ADDENDUM NO. 1

BID No. 10P2

**CHAFFEY COMMUNITY COLLEGE DISTRICT
FONTANA CENTER EXTERIOR PAINTING
FONTANA, CALIFORNIA
COUNTY OF SAN BERNARDINO**

Item 6: **Add** the attached Sheet No. AD-1.1 entitled "Trash/Equipment Enclosure Elevations" (8/12/09) to the end of the Instructions to Bidders.

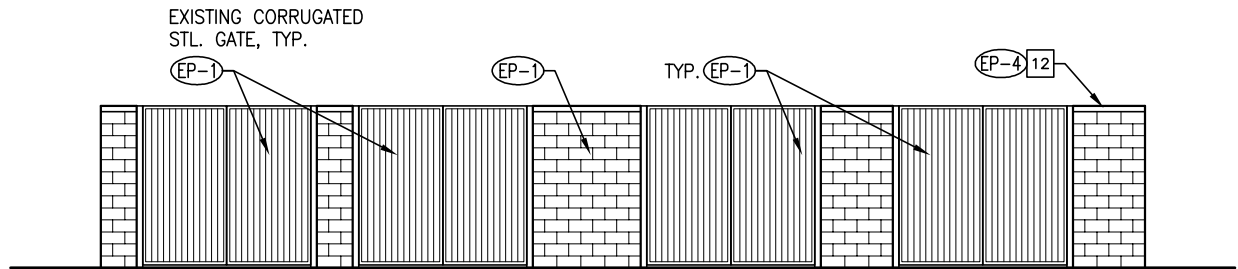
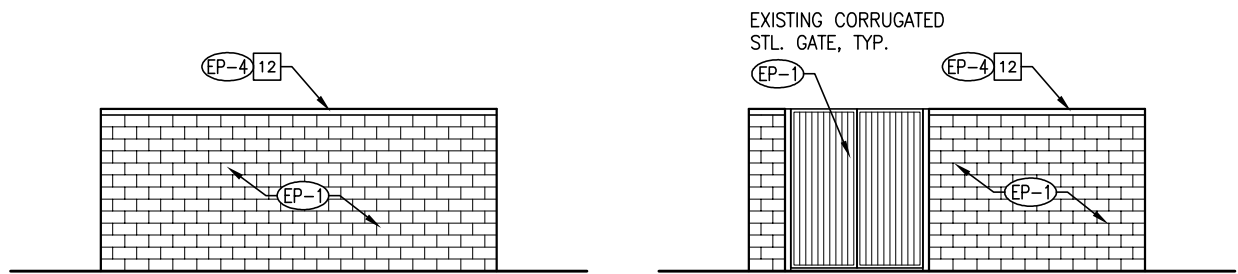
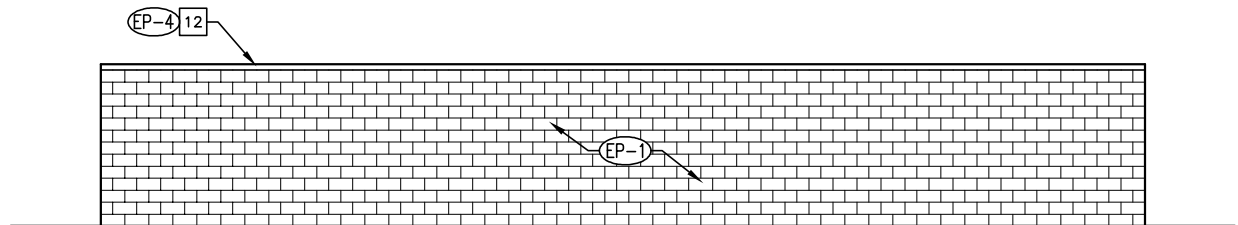
A. Contractor shall include Sheet No7. AD-1.1 within their bid.

NOTE:
Paint all interior and exterior surfaces of masonry enclosure and gates. Refer to Sheet A2.1 for keynote legend.
